ADDENDUM NO. 2

TO: PLANS AND SPECIFICATIONS FOR THE STATE OF MISSOURI

HVAC Improvements
Fulton Reception and Diagnostic Center
Fulton, Missouri
Project No.: C2406-01

1. ALL MASONRY SHALL BE CONSTRUCTED AS SECURITY WALLS, GROUTED FULL WITH #4 BAR IN EACH CMU CELL TO 10'-0" ABOVE INMATE ACCESSIBLE AREA, UNO.

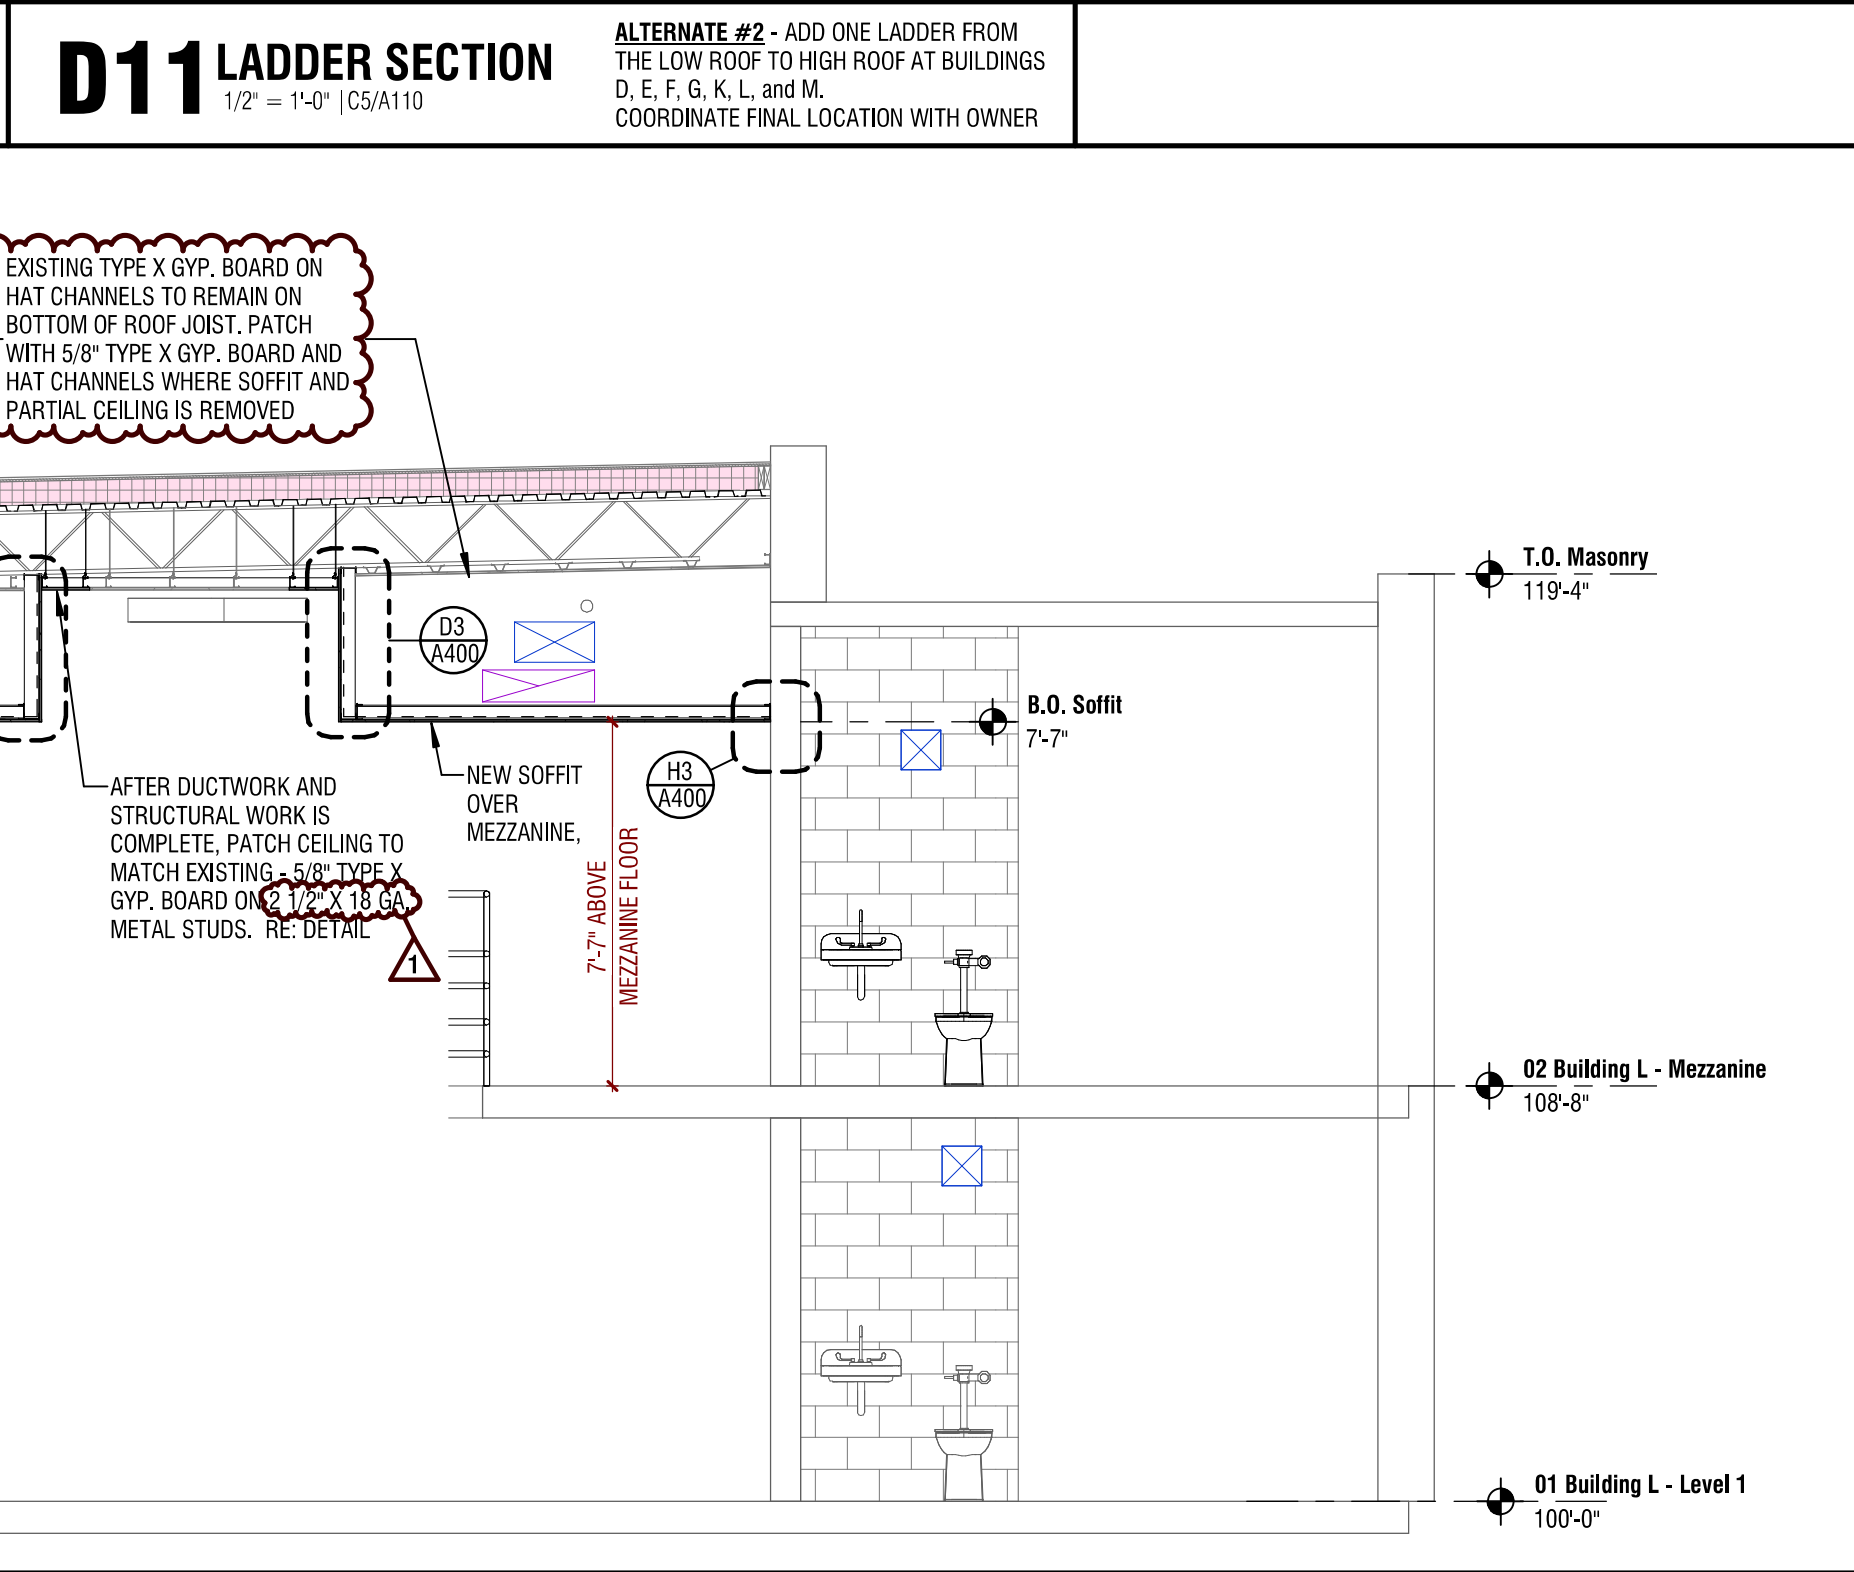
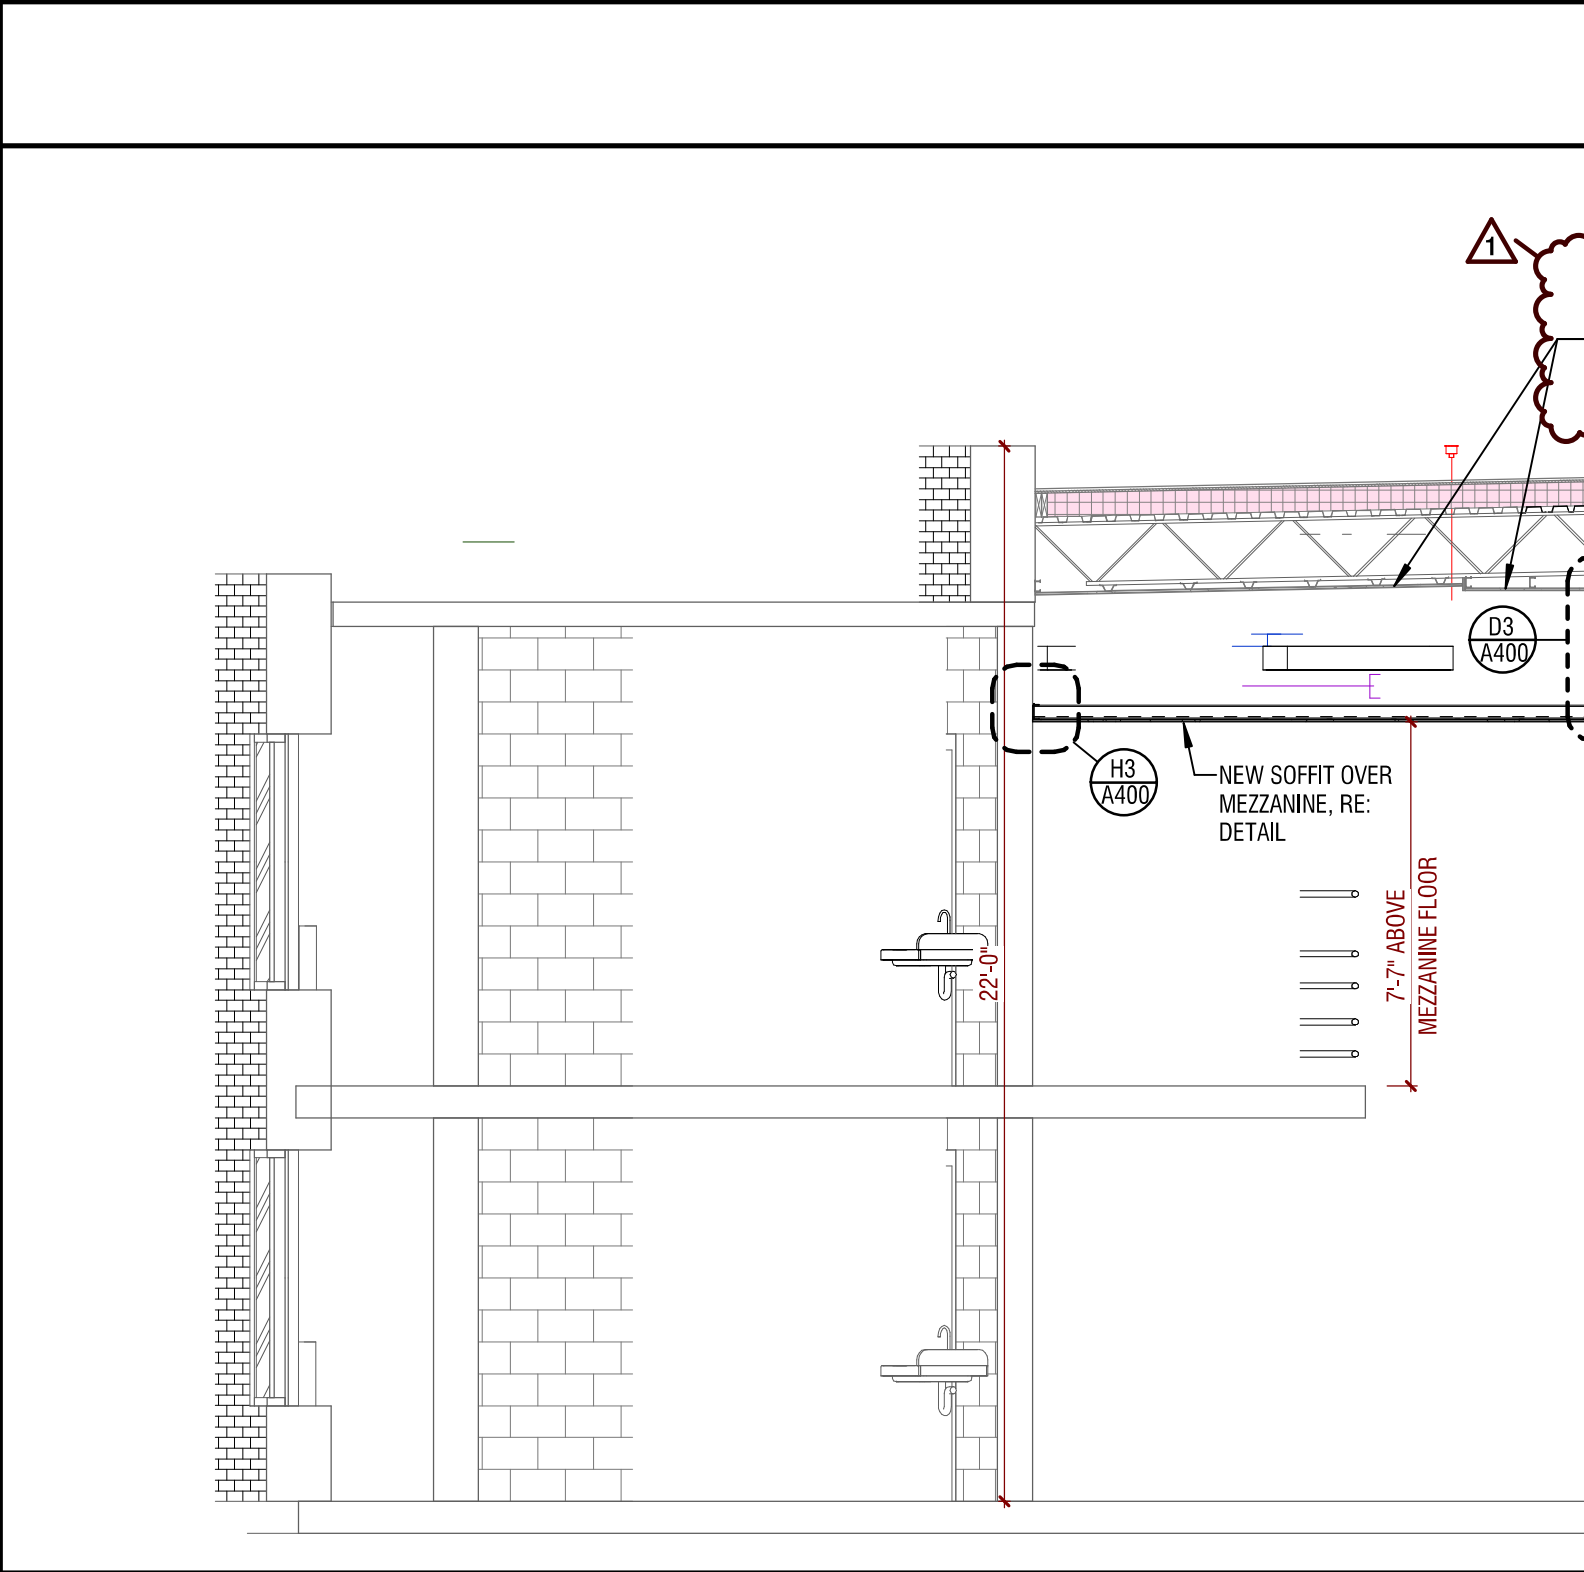
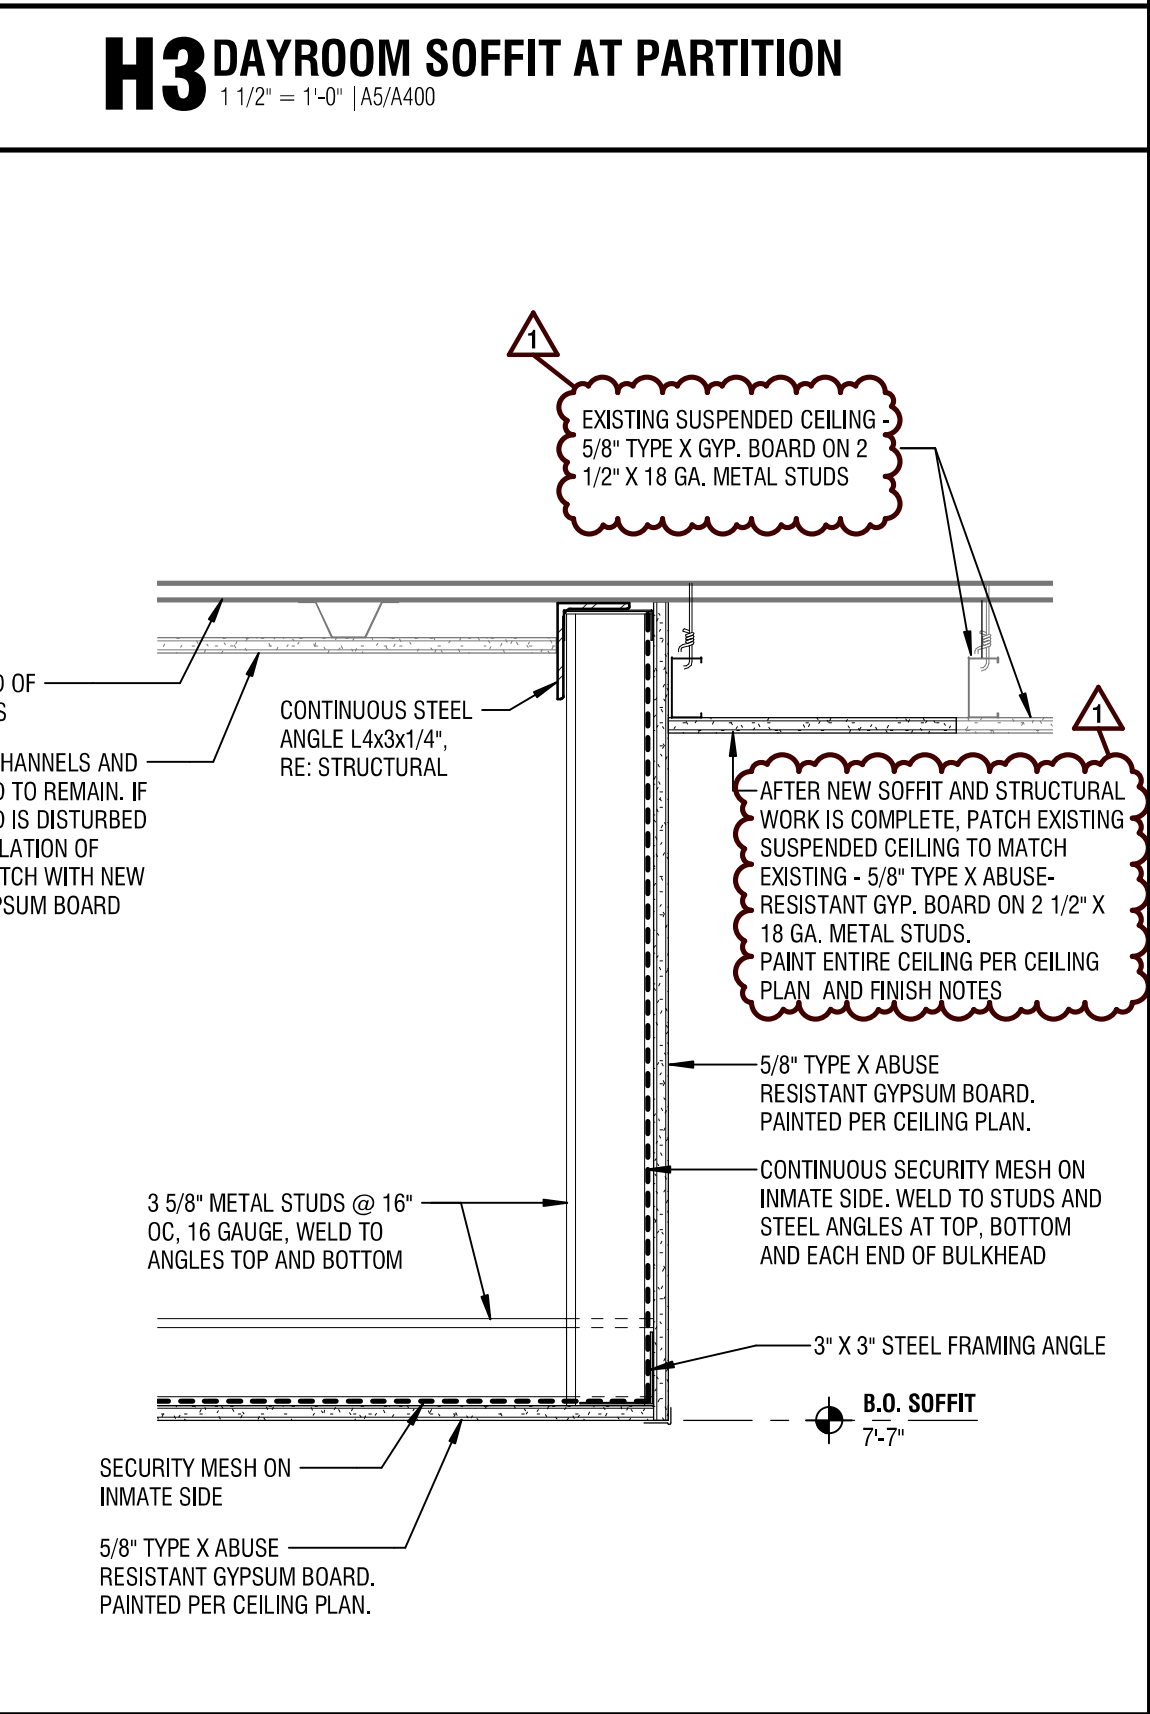
- 1) A5 and A12 Building Sections:
 - a. Revise the existing ceilings to remain.
 - b. Edited notes for existing ceilings and materials.
- 2) Detail D3 Dayroom Soffit
 - a. Edited notes for existing ceilings and materials.

11. Unit Price No. 1 remove and replace suspended g.b. ceiling and furring. Looking at A5/A400 it appears that there are two different, existing ceiling systems: one that is a suspended grid (one detail shows studs and another indicates CRC (cold rolled channels)) with abuse board above the Dayrooms and one that is a hat channel furring system with abuse board that attaches to the underside of the sloping bar joist. The question is that it appears the detail is a bit inaccurate because it shows the furring system as suspended and not attached to the underside of the bar joist. So, which is this

portion of ceiling: suspended or attached to the bar joist as a furring system as described in the Unit Price description?

Response: The existing ceilings in the dayrooms are both ceiling systems: furring channels and gyp. board directly attached to the bar joists (for smoke control) and the suspended ceilings. Sheet A400 has been revised to better reflect the existing ceiling systems and revised notes. For Unit Price #1, the ceiling system is 5/8" type X abuse-resistant gypsum board on suspended 2 1/2" x 18 ga. metal studs at 16" o.c. The patching of the existing ceiling does not include the new mezzanine soffits, which is a set quantity.

Response: Reference to revised drawing A400 for updated details and notes.

M101.Ba

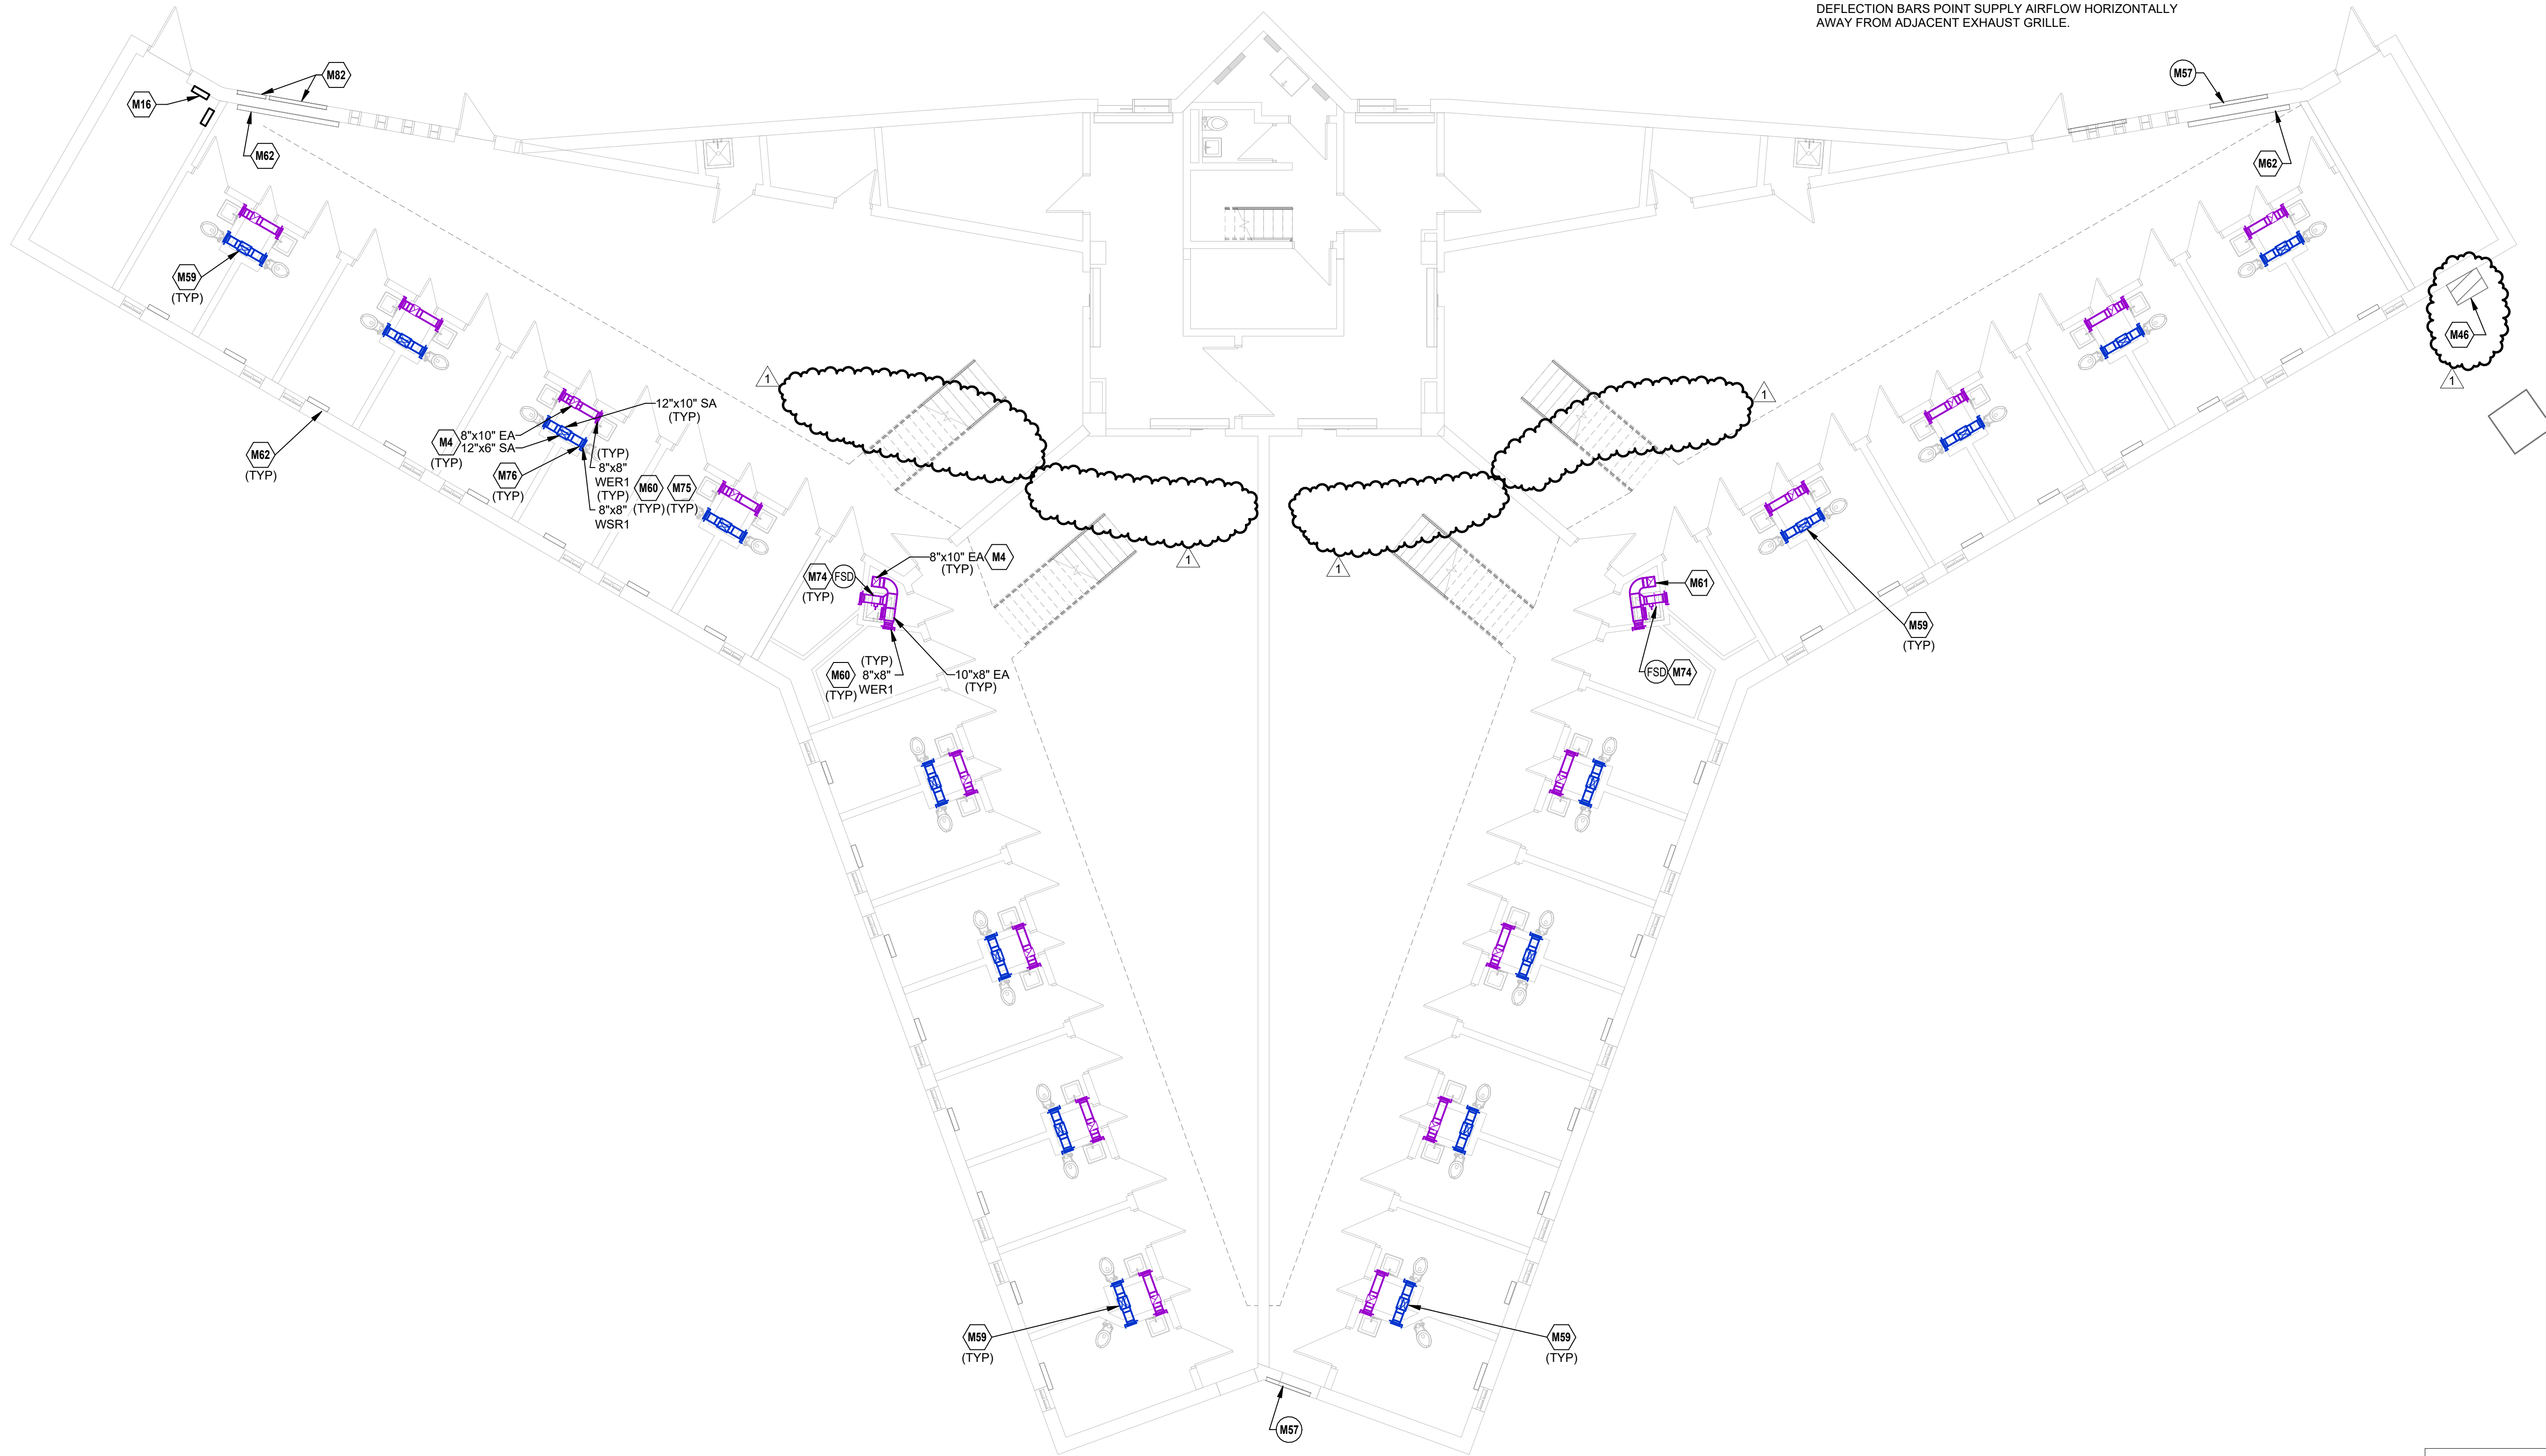
- 1) Remove wall-mounted space sensors.
- 2) Add note that sheet is provided for reference only. Scope has been removed from construction documents.

THIS SHEET IS PROVIDED
FOR REFERENCE ONLY.
SCOPE WAS REMOVED FROM
CONSTRUCTION DOCUMENTS
IN ADDENDUM #2.
